DEVELOPMENT APPLICATION

19 DARLING POINT ROAD, DARLING POINT NSW 2027

SCHEDULE OF AMENDMENTS FOR REVISION DA2 - HIGHLIGHTED AND CLOUDED RED

1007 Ascham Boarding House

TITLE GA PLANS **GROUND LEVEL** SCALE: 1:200 @ A3 DRAWING NO A-11-008

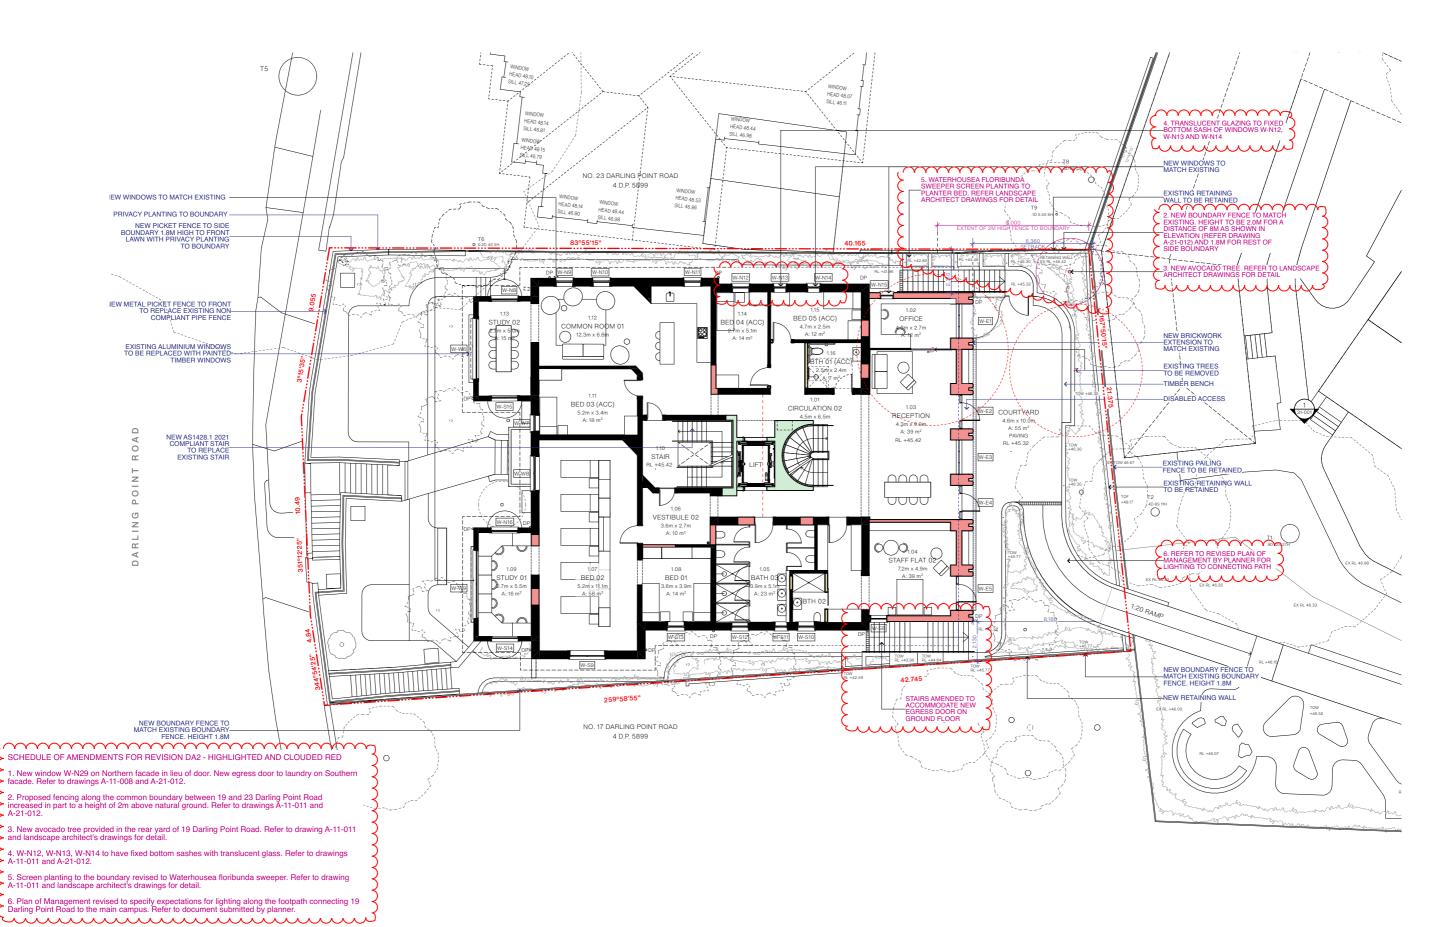
1. New window W-N29 on Northern facade in lieu of door. New egress door to laundry on Southern → facade. Refer to drawings A-11-008 and A-21-012.

TITLE **GA PLANS** LEVEL 01 SCALE: 1:200 @ A3 DRAWING NO A-11-011

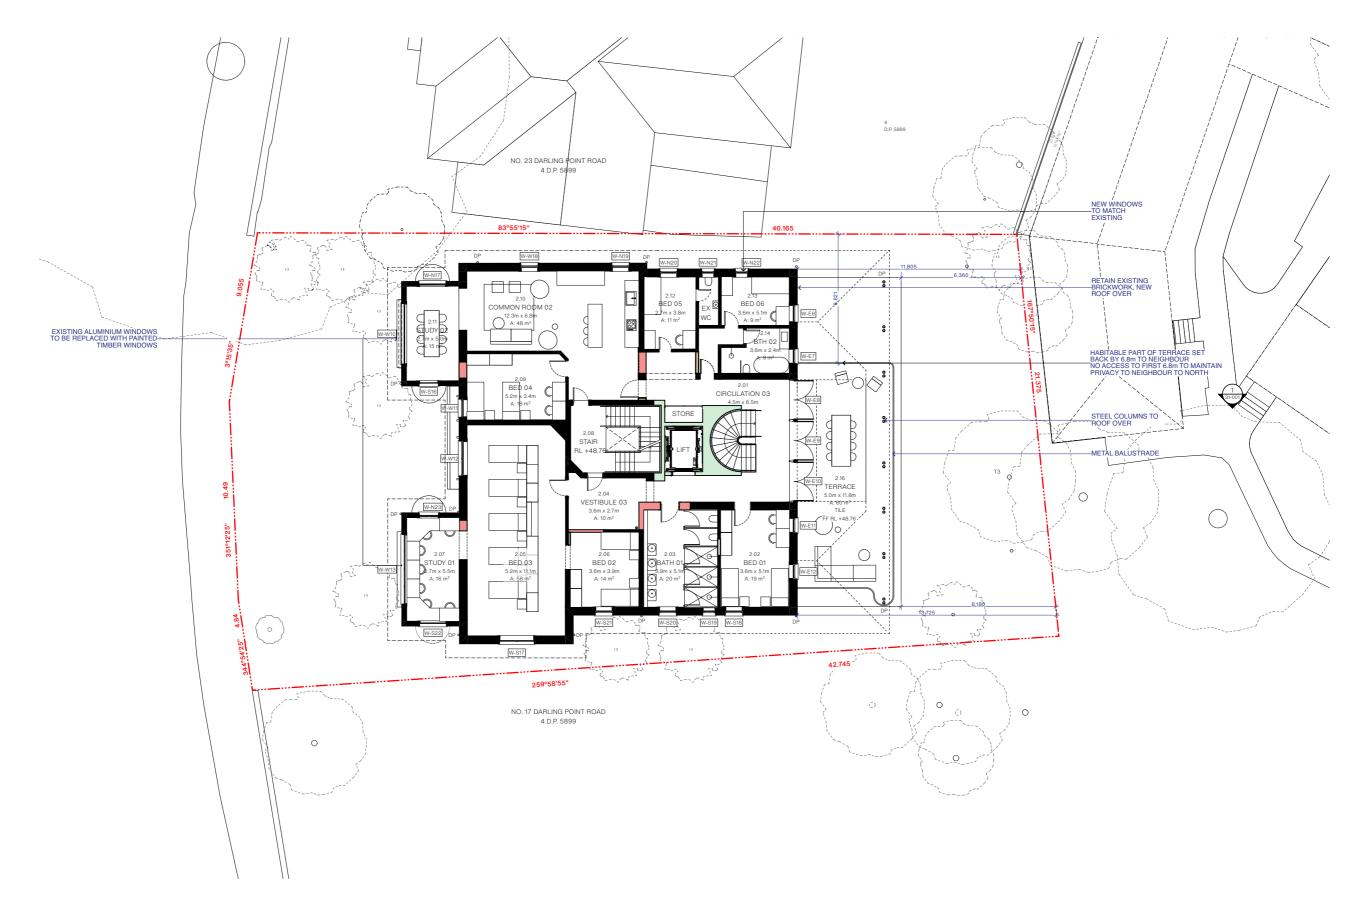
2. Proposed fencing along the common boundary between 19 and 23 Darling Point Road increased in part to a height of 2m above natural ground. Refer to drawings A-11-011 and A-21-012.

3. New avocado tree provided in the rear yard of 19 Darling Point Road. Refer to drawing A-11-011 and landscape architect's drawings for detail.

4. W-N12, W-N13, W-N14 to have fixed bottom sashes with translucent glass. Refer to drawings
 A-11-011 and A-21-012.

Screen planting to the boundary revised to Waterhousea floribunda sweeper. Refer to drawin A-11-011 and landscape architect's drawings for detail.
